South Coast Air Quality Management District

Final Environmental Impact Statement/Report (Draft EIS/EIR) for the Proposed Berths 212-224 (YTI) Container Terminal Improvements Project

Figure R.7: Mitigated Proposed Project Federal 1-hr NO₂: Operation

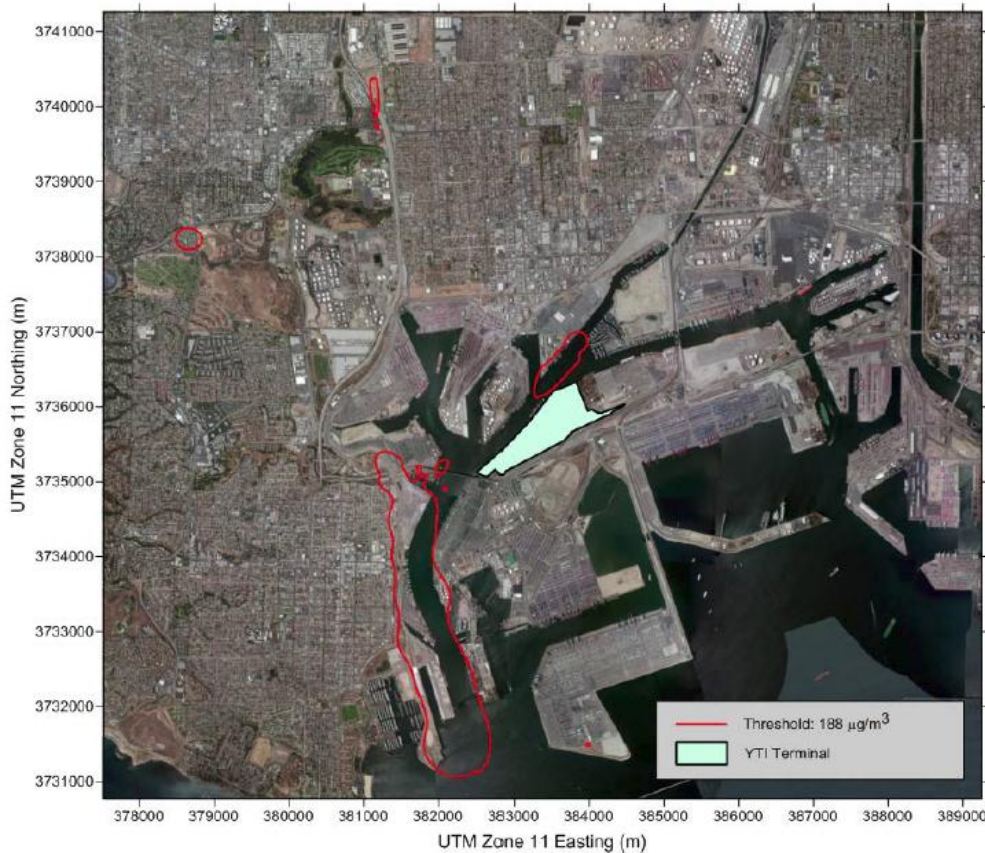
The Final EIS/EIR provides a map which depicts the area of NO₂ impact from the project. (Final EIS/EIR Figure R.7, shown below). This map was prepared using a methodology that combined dispersion modeling of emissions and monitoring data from a nearby air monitor.² This map in the Final EIS/EIR shows exceedance of the federal NO₂ standards occurring primarily over water and port waterfront property, and generally not extending into a residential area.

Figure 1. Map Created from Dispersion Modeling Output File Provided to SCAQMD Staff. Yellow shading shows area with NO₂ concentrations that exceed federal NAAQS of 188 ug/m³. Red shading shows areas with NO₂ concentrations that exceed 250 ug/m³.

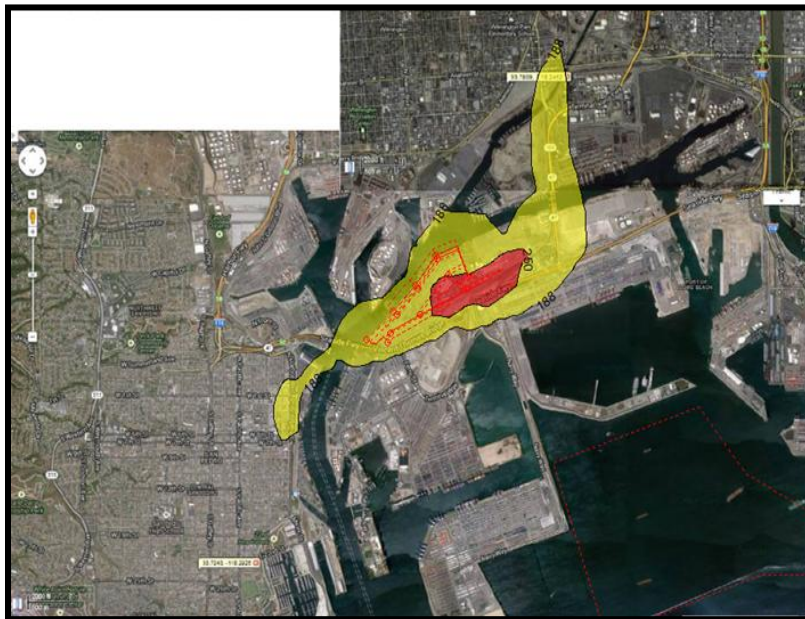
Recent Plot of Facility-Specific Data. Using the modeling data underlying the above map in the Final EIS/EIR, SCAQMD staff has plotted areas expected to exceed the federal NO₂ standard solely due to emissions from the YTI facility.³ This information is provided in the two maps below. The maps are based solely on data that is specific to the YTI facility, i.e. emissions, source location, wind direction, and other pertinent data. The first map (Figure 1) shows in yellow the area of NO₂ exceedance resulting from baseline emissions in 2012. The second map (Figure 2) shows in yellow the area of exceedance resulting from the YTI facility after the project is completed and in operation. Since these analyses solely modeled emissions from the YTI facility, actual areas of exceedance could be larger in both cases due to cumulative background NO₂ levels created by other sources.

The maps show that the YTI terminal by itself creates NO₂ levels exceeding the federal standard. With the project, the modeled area of exceedance increases to encompass an area with over one thousand residences.

Figure 2. Map Created from Dispersion Modeling Output File Provided to SCAQMD Staff. Yellow shading shows area with NO₂ concentrations that exceed federal NAAQS of 188 ug/m³. Red shading shows areas with NO₂ concentrations that exceed 250 ug/m³.

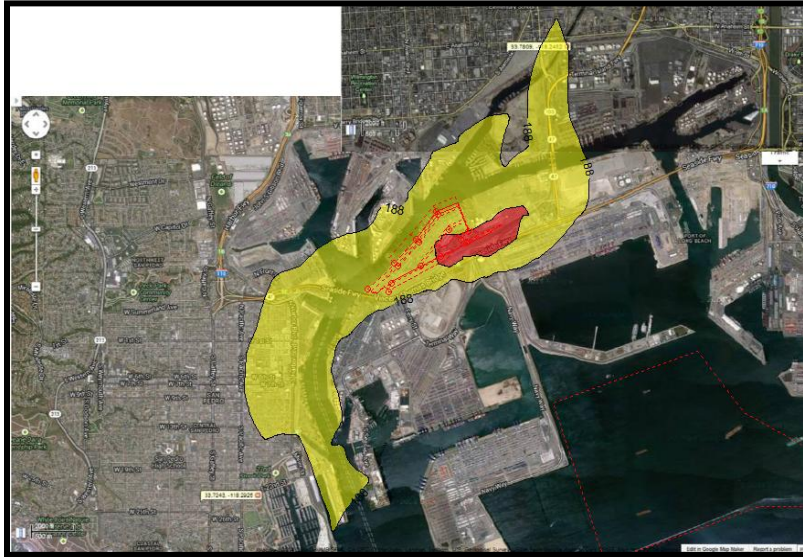
Implications. The above maps indicate that the project will have a greater impact than previously understood by causing the federal NO₂ standard to be exceeded in a large residential area. This more specific information is available and should be considered by the Commission as part of its implementation of CEQA. These maps provide a more accurate representation of potential air quality impacts from the YTI facility before and after the project is built. CEQA requires that the agency select an approach for analysis "that will give the public and decision makers the most accurate picture practically possible of the project's likely impacts." (*Neighbors for Smart Rail v. Exposition Metro Line Construction Auth.* (2013) 57 Cal.4th 439, 449.)
